Subject: SQUEAK NOISE FROM ENGINE COMPARTMENT	Bulletin No: 01-013/13
	Last Issued: 05/28/2013

- This bulletin supersedes the previous bulletin 01-021/12 issued on 07/17/12, 08/24/12 and 11/28/12. The APPLICABLE MODEL(S)/VINS, DESCRIPTION, REPAIR PROCEDURE, PARTS, and WARRANTY INFORMATION have been revised.
- Changes are noted below in Red beside the change bar.

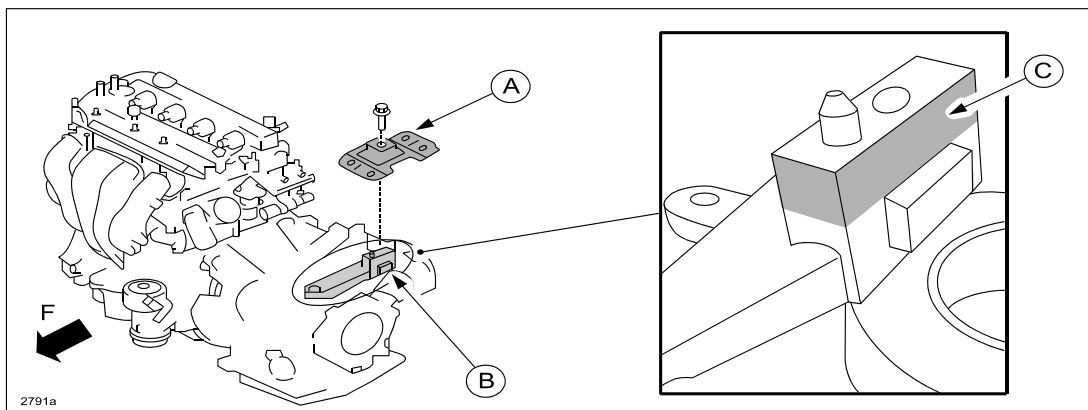
Some vehicles may exhibit a squeak noise from the engine compartment when the vehicle starts moving and/or at the time of transmission shifting. This is caused by stick-slip noise occurring at the contact surfaces between the No. 4 engine mount rubber and the No. 4 engine mount bracket when the engine shakes back and forth.

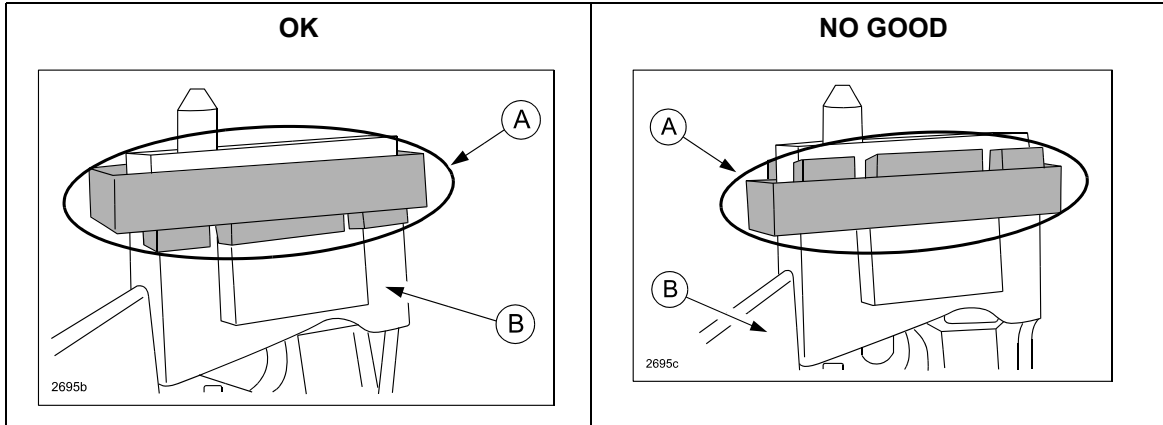
4. Install the new mount rubber (A) on the No. 4 engine mount bracket (B).

NOTE: Install the mount rubber (A) with the notched side facing down.
